PCI-SIG DRAFT ENGINEERING CHANGE NOTICE

TITLE:	PCI Express Capability Structure Expansion
DATE:	21 March 2005, updated 12 August 2005
AFFECTED DOCUMENT:	PCI Express Base Specification Revision 1.1
SPONSOR:	David Harriman, Intel Corporation

1 Summary of the Functional Changes

Figure 7-9: PCI Express Capability Structure

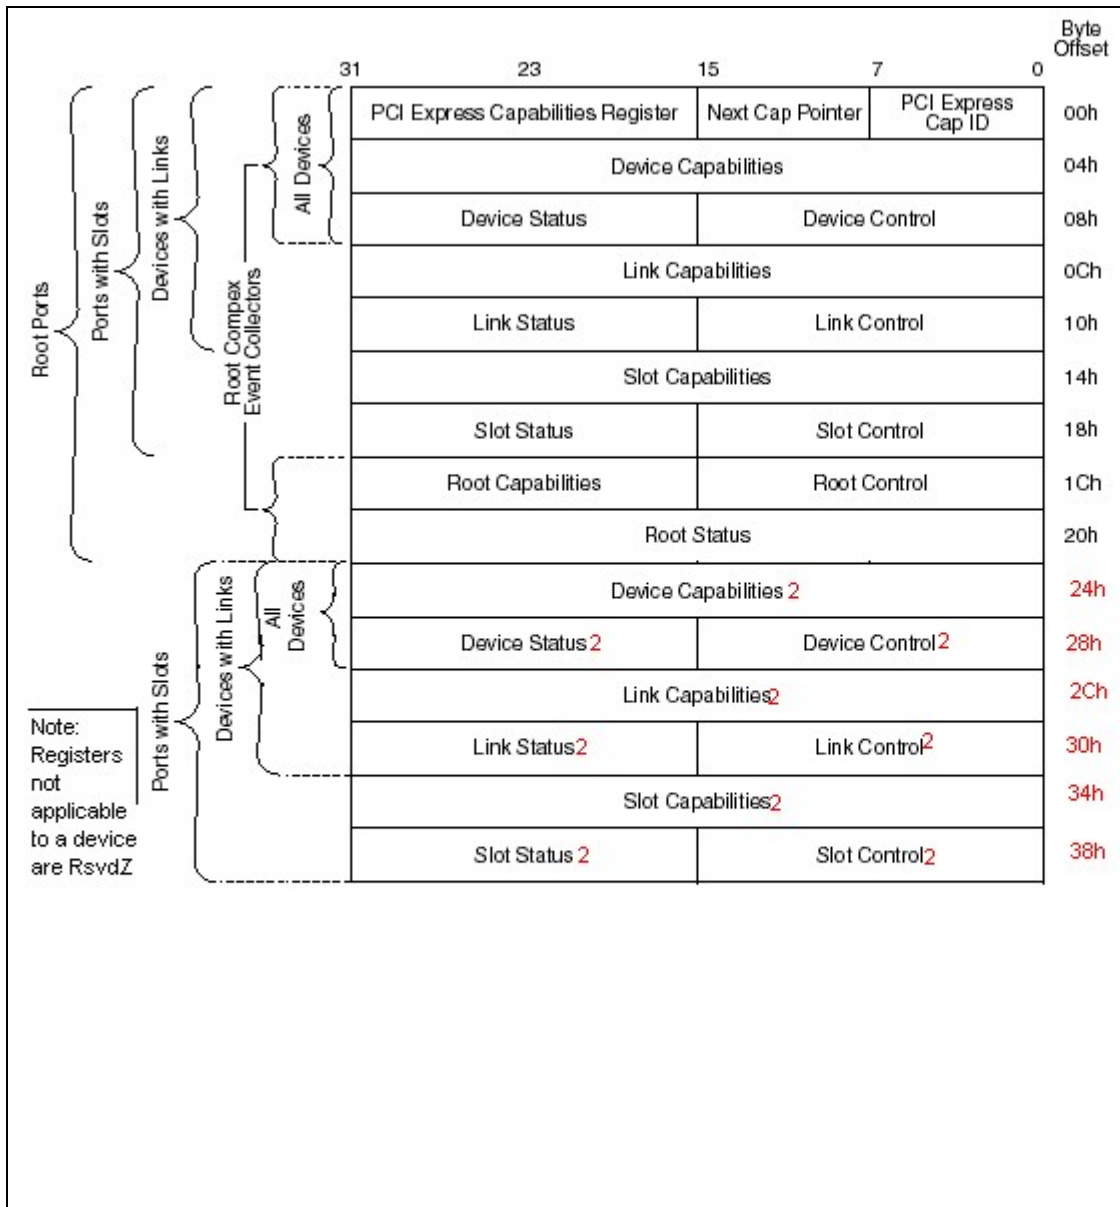
Extends the Device, Link and Slot register groups in the PCI Express Capability Structure by adding additional registers to the end of the capability structure. Changes the capability version to reflect the modified structure.

Figure 7-9 details allocation of register fields in the PCI Express Capability structure.

The PCI Express Capabilities, Device Capabilities, and Device Status/Control registers are required for all PCI Express devices. Device Capabilities 2, and Device Status 2/Control 2 registers are required for all PCI Express devices that implement capabilities requiring those registers.

The Link Capabilities and Link Status/Control are required for all Root Ports, Switch Ports, Bridges, and Endpoints that are not Root Complex Integrated Endpoints. Link Capabilities 2, and Link Status 2/Control 2 registers are required for all Root Ports, Switch Ports, Bridges, and Endpoints (except for other than Root Complex Integrated Endpoints) that implement capabilities requiring those registers. For devices that do not implement the Link Capabilities, Status, Control, Capabilities 2, Status 2, and Control 2 registers, these spaces must be hardwired to 0. Endpoints are not required to implement registers other than those listed above and terminate the capability structure.

Slot Capabilities and Slot Status/Control registers are required for Switch Downstream and Root Ports if a slot is implemented on the Port (indicated by the Slot Implemented bit in the PCI Express Capabilities Register). Slot Capabilities 2, and Slot Status 2/Control 2 registers are required for Switch Downstream and Root Ports if a slot is implemented on the Port and the device implements capabilities requiring those registers.

Root Ports and Root Complex Event Collectors must implement the Root Capabilities, Status and Status/Root Control registers. in addition to PCI Express Capabilities, Device Capabilities and Device Status/Control registers For devices that do not implement the Link Root Capabilities, Status, and Control, Capabilities 2, Status 2, and Control 2 registers, these spaces must be hardwired to 0.

Slot Capabilities and Slot Status/Control registers are required for Switch Downstream and Root Ports if a slot is implemented on the Port Root Control/Status registers are required for Root Ports. Root Ports must implement the entire PCI Express Capability structure.
